STAFF RECOMMENDATION 4406 Elkins Avenue July 18, 2018

Application: New Construction – Infill and Outbuilding
District: Park and Elkins Neighborhood Conservation Zoning Overlay
Council District: 24
Map and Parcel Number: 091160067.00
Applicant: Potter Brothers Construction
Project Lead: Jenny Warren, jenny.warren@nashville.gov

Description of Project: The application is for new construction, including a single family home and an outbuilding.

Figure 2: Proposed front elevation.

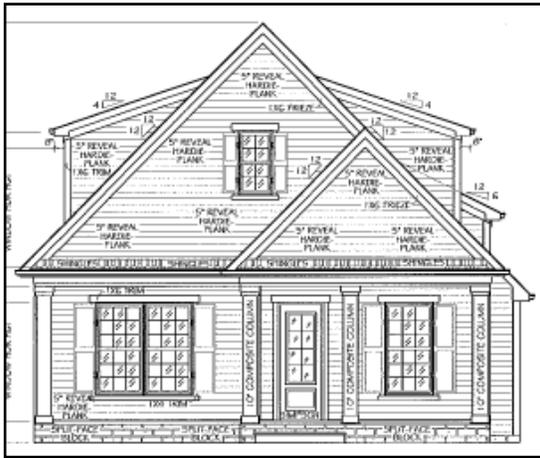
The proposed infill is thirty-one feet (31') wide, which is generally consistent with the historic context. Most of the contributing houses on the block have articulated massing. For example: the three houses to the left all have a projecting front gable with side porches at the front setback, such that the front gabled massing is approximately sixteen feet (16') wide, with each house stepping out to a full thirty-one feet (31') of width fifteen feet (15') back from the front façade. The proposed house has a front-gabled form with a recessed front porch and will have the full thirty-one feet (31') of width set behind a nine foot (9') deep porch.

The proposed infill is approximately twenty-eight feet, two inches (28'2") tall. The contributing houses on the immediate block are between approximately nineteen feet and twenty-six feet (19'-26') tall. There are taller houses nearby, but at twenty-eight feet, two inches (28'2"), this will be the tallest house on the block. The front-gabled form tends to accentuate this height, as the full width and height are visible on the front façade, as opposed to other house forms that may be more articulated. The proposed eave height is approximately eleven feet (11') from grade and the proposed foundation height is approximately one foot, six inches (1'6"). The proposed eave and foundation heights are consistent with the immediate historic context, and are appropriate. Staff recommends that the proposed house not exceed an overall height of twenty-six feet (26') from grade.

Staff finds that a one-and-a-half story form could be appropriate, particularly given the larger neighborhood context, but due to the one-story character of the immediate vicinity, Staff recommends that the overall height of the house be reduced to a maximum of approximately twenty-six feet (26'). This would still allow for second story living space, but would better respect the character of the historic block.

1. The height of the house shall be reduced to a maximum of twenty-six feet (26');
2. The front setback of this house shall be halfway between the historic home to the left and the side-elevation of the corner historic home on the right. This setback must be verified by Staff after field staking, prior to pouring the foundation;

Figure 7: Proposed left elevation, note lack of glazing in dormer on the right

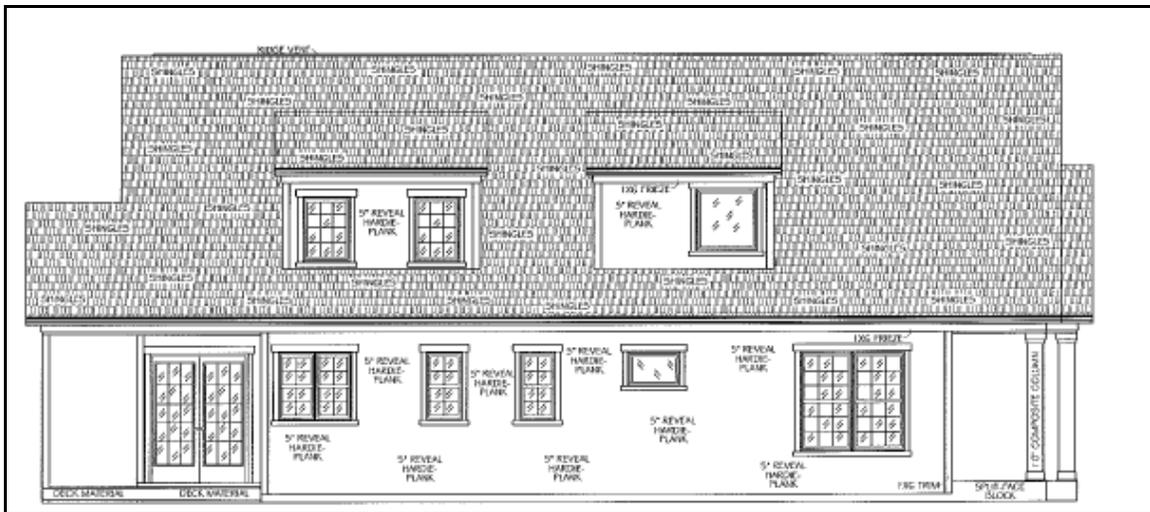
Roof form: The roof is a front-gabled roof form with a projecting front gable at the porch. Both have a slope of 12/12. Both side elevations contain two shed dormers with a roof pitch of 4/12. The dormer on the left elevation, closest to the front, features only one window: dormers should be primarily glazing, so Staff would recommend that a second window is added to this dormer – the window could be frosted for privacy, as it will be within the master shower (see Figure 7). This roof form and use of dormers is compatible with the historic context and Staff finds the roof to be appropriate.

Proportion and Rhythm of Openings: The windows are all generally twice as tall as they are wide, thereby meeting the historic proportions of openings. There are two small square windows flanking the projecting bay on the right elevation (see Figure 7), Staff finds these to be appropriate as they are so far set back from the street, and because smaller windows of this type are sometimes seen flanking chimneys in historic examples. A small horizontal window on the left elevation could also be appropriate, because there is only one. There are no large expanses of wall space without a window or door opening. Grouped windows should all have four inch (4") nominal mullions. Staff finds the project's proportion and rhythm of openings to meet Section II.B.1.g.

4. A second window shall be added to the dormer on the left elevation which currently contains only one window;
5. Staff approve the final roofing color, trim material, front & rear porch steps and flooring material, rear porch post material, windows and doors, driveway and walkway materials

Figure 8: Proposed right elevation, note wall dormer

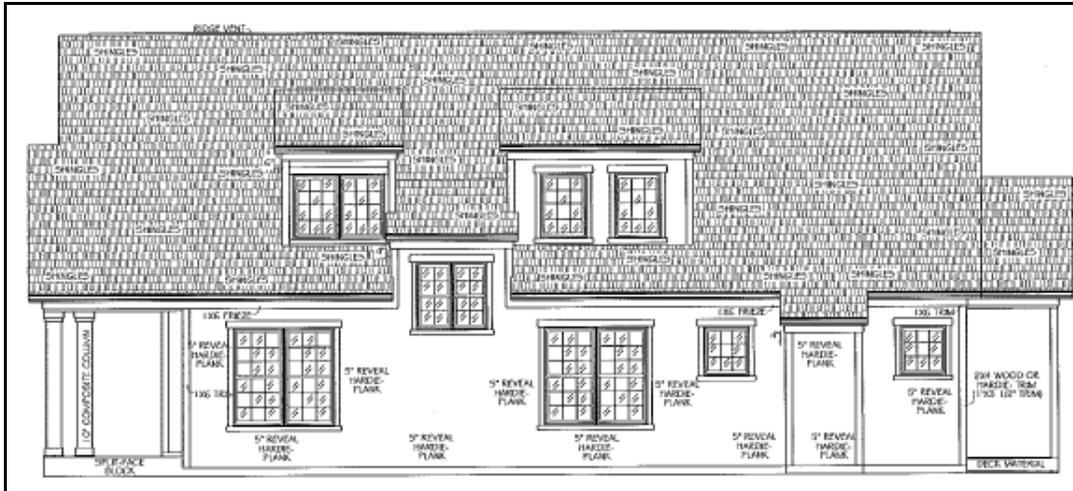
The right elevation contains a wall dormer (see Figure 8). Wall dormers are not typical in the historic context, but Staff finds that this single wall dormer could be appropriate because it is on a secondary façade, is no wider than the typical window opening on the house and does not project beyond the main wall. The project meets section II.B.1.e.
